# ALERT SERVICE BULLETIN

REPLACEMENT OF ROTARY BUCKLE

SERVICE BULLETIN NUMBER  
1150004-25-A01  
ISSUE 7

ISSUED BY:  
AMSAFE INC.  
1043 N. 47<sup>th</sup> AVENUE  
PHOENIX, AZ USA 85043  
TEL: (602) 850 2850 FAX: (602) 850 2812

**Figure 2: Inspect the Cover for Looseness**

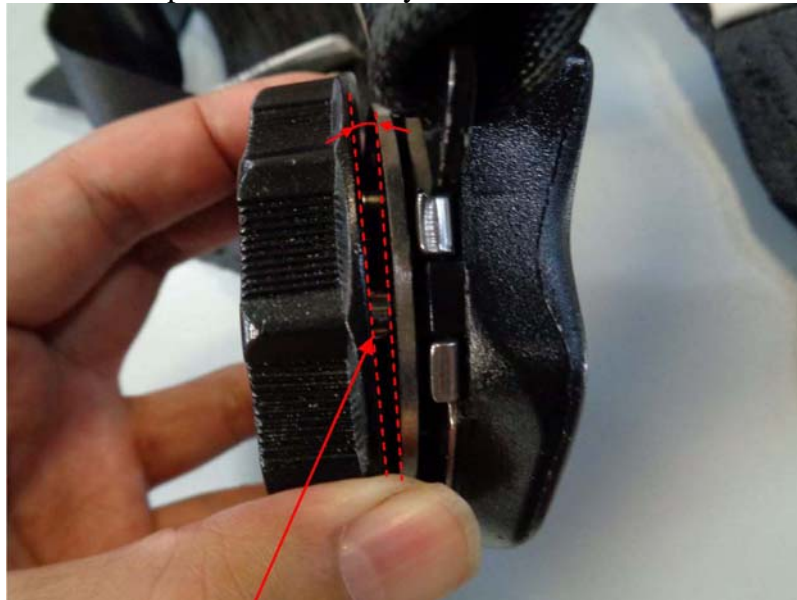
AmSafe has determined that a fastener may not have received the correct placement of thread locker which may allow the buckle cover to loosen and impairing proper function of the buckle. A buckle with this condition will hinder egress. All operators should inspect all of their restraint PNs affected by this Service Bulletin. If the buckle build date is outside the date range

indicated in paragraph 1.A., (see Paragraph 2.A. for information on identifying the build date) then no further action is necessary. If the buckle build date is within the date range of this service bulletin, or if the build date is illegible or missing, check the buckle cover (front face that rotates to release the buckle). Viewing the buckle from the side, grasp the cover with one hand and attempt to rock the cover back and forth relative to the parallel plane of the buckle base (See Figure 2). If the cover is able to rock, so that there is a changing gap width between the buckle cover and buckle base, then the buckle must be replaced immediately.

If the above condition does not exist, the restraint can be returned to service, the buckle to be replaced within 180 days of the inspection, during a suitable maintenance interval, per §2 (Accomplishment Instruction). Buckles replaced under this service bulletin, whether due to manufacturing date within the build dates indicated or an illegible manufacturing date on the label shall be free of charge.
